#7918 Richmond Great Point Development, LLC
Definitive Subdivision
42B, 48R, 54R Skyline Drive & 20 Davkim Lane
Map 79 Parcels 44.1, 45.1, 46
Map 68 Parcels 56.1, 57

Subject: Submittal of Application for Approval of a Definitive Subdivision Plan
42 (Rear) 48 (Rear) and 54 (Rear) Skyline Drive Properties and 20 Davkim Lane Property

**RE: Engineering Review of the Proposed Clay Street (Rear of Skyline Drive)
Definitive Subdivision**

TYPICAL ROADWAY CROSS SECTION
 NOT TO SCALE

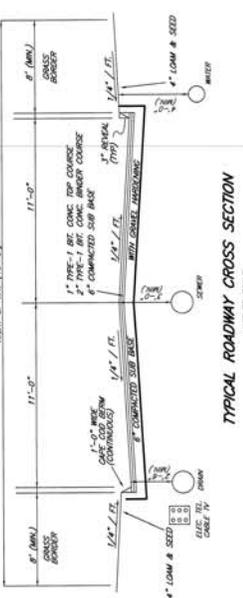
7. We recommend that proposed driveway aprons (in conceptual locations), with appropriate driveway detail, be shown on the plans.
8. The roadway cross section detail on sheet 5 indicates *“6” Compacted Sub Base With Gravel Hardening.* We recommend that this roadway base material be specified with a design sieve specification (such as MA DOT M2.01.7, M1.03.0 or similar).

DETAIL SHEET 1 OF 1
 SHEET 8 OF 9

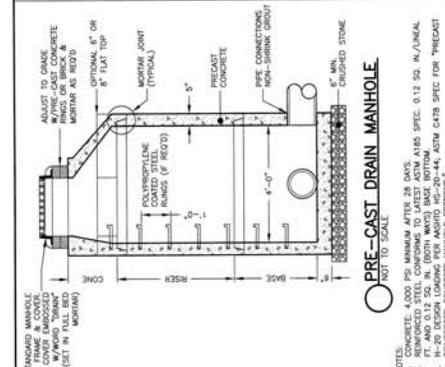
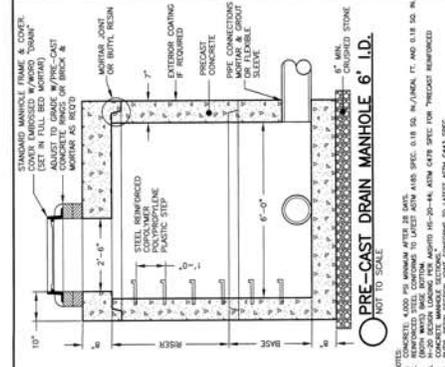
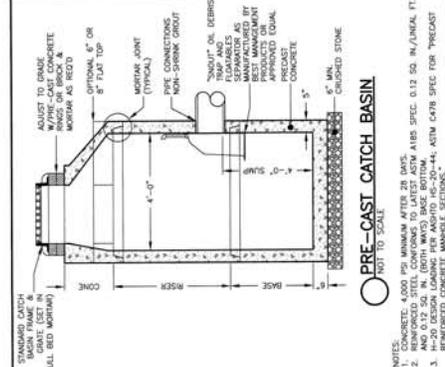
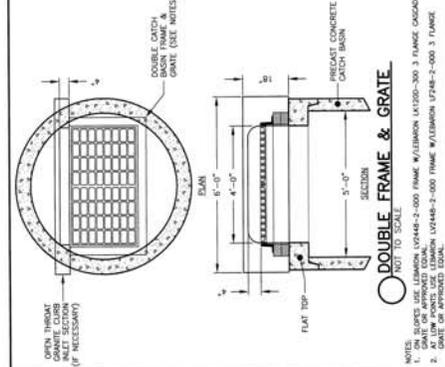
2. We recommend that the plans (sheets 4 & 8) show the gross length and width of the proposed infiltration bed with the MC-3500 StormTech™ chambers, for clarity during construction.

- a. Page 63 of the report in Appendix B (HydroCAD® calculations): The elevations shown for the subsurface infiltration chambers are different from those shown in the “MC-3500 Typical Cross-Section” detail on sheet 8. Please clarify and revise accordingly.
- b. Page 2 of the report in Appendix D “Checklist for Stormwater Report”: The Checklist should be stamped, signed, and dated by the engineer.

Street Network Plan in
NANTUCKET, MASS.

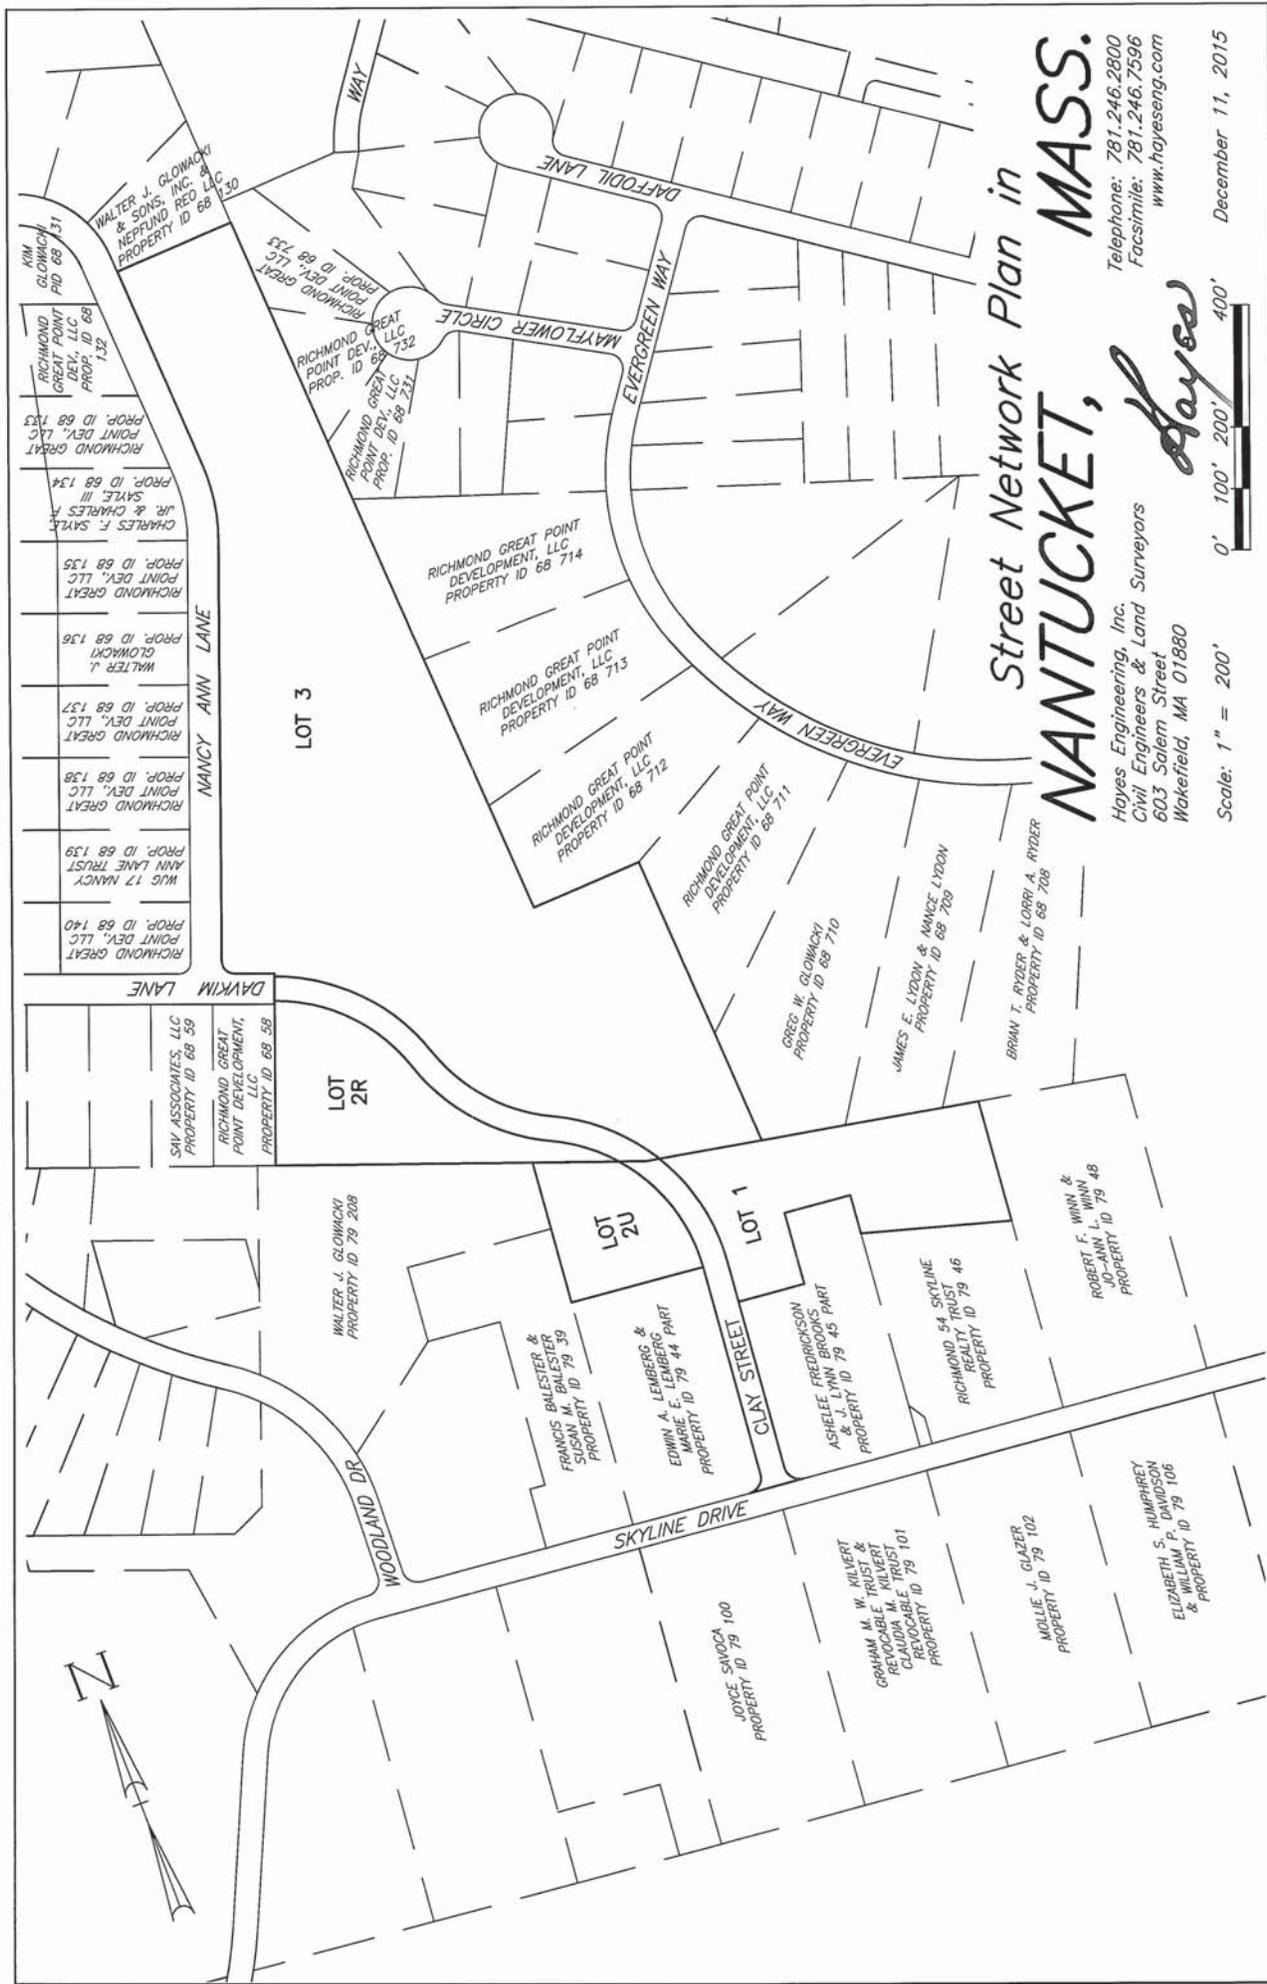
See the Street Network Plan for an overall view of this area. The site is located in both the Land Use General 2 (LUG-2) and Commercial Neighborhood (CN) Zoning Districts and the Public Wellhead Recharge Overlay District. No wetland areas are located on the subject parcels.
